## ***Interactive comment on “Validating HY-2A CMR Precipitable Water Vapor Using Ground-based and Shipborne GNSS Observations” by Zhilu Wu et al.***

Response to Reviewer

Fig. 2. Figure 4

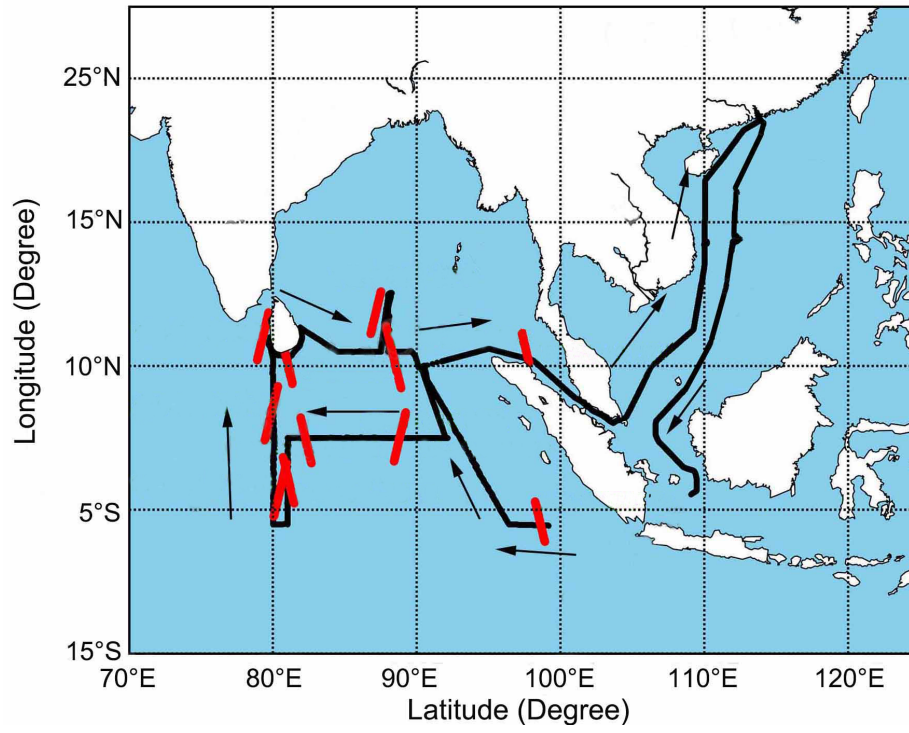
Figure 4 has to be improved. The crossover time cannot overlap the crossover point, especially when green and red colors are used, because it makes it difficult to read them. The crossover time should not also overlap with the ship trajectory. Response: Thank you for the suggestion. We revised Figure 4 as suggested.
